Permit Type Building/Residential/Misc/Solar Panel Permit Number B23004053 Opened Date 10/05/2023
 Description of Work SFD / INSTALL (24) ROOF MOUNTED SOLAR PANELS AND (36) GROUND MOUNTED SOLAR PANELS

LOCATION DRAWING
 1656 WOODSTOCK ROAD
 3rd ELECTION DISTRICT
 HOWARD COUNTY, MARYLAND

AMERICAN DESIGN AND BUILD
 -PROJECT-
 SEEKINS RESIDENCE (PV23312gmr)
 1656 WOODSTOCK ROAD
 WOODSTOCK, MD 21163

HEYN PROPERTY, LOT 5
 (PLAT 13271)
 PLOT PLAN

SITE PLAN
 SCALE: 1"=30'

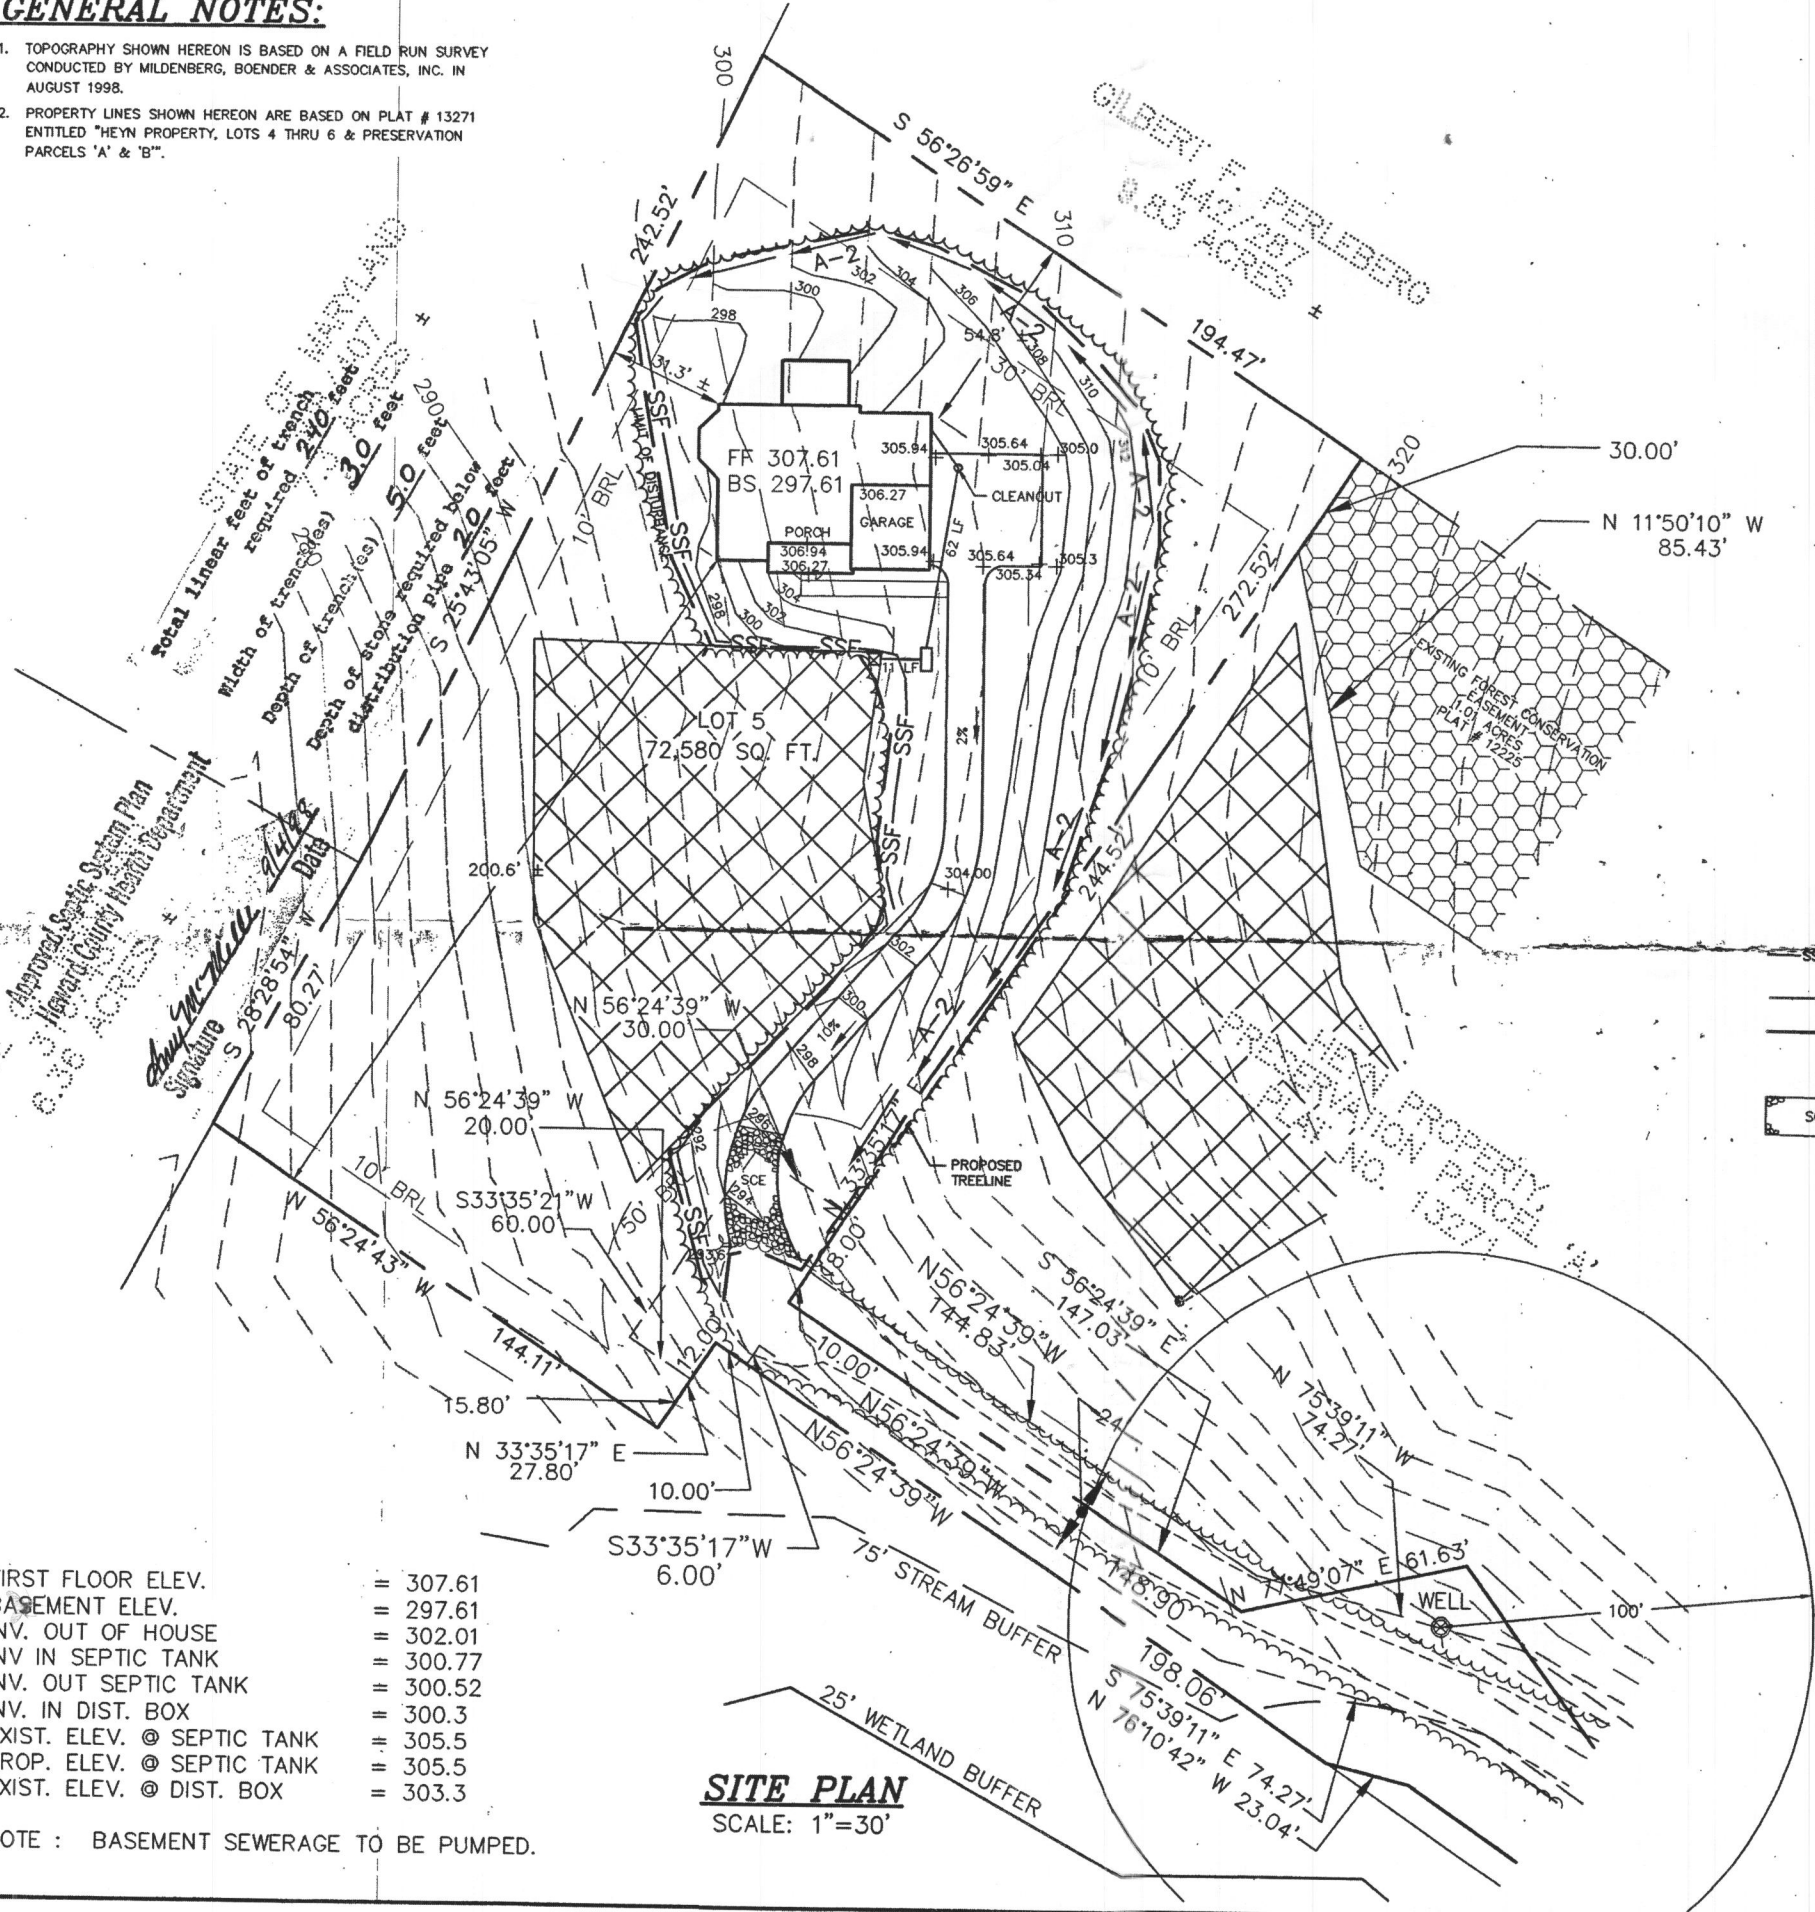
TOPOGRAPHY MORE DIFFICULT THAN INDICATED ON SITE PLAN.

INSTALL INITIAL TRENCH HIGHER THAN PLANNED,

! C. WARDER DRIVEWAY TO MAXIMIZE FUTURE REPAIR OPPORTUNITY 12/28/98 CW

12/30/98 Specs altered due to topography concerns suitable soil conditions present. DKS
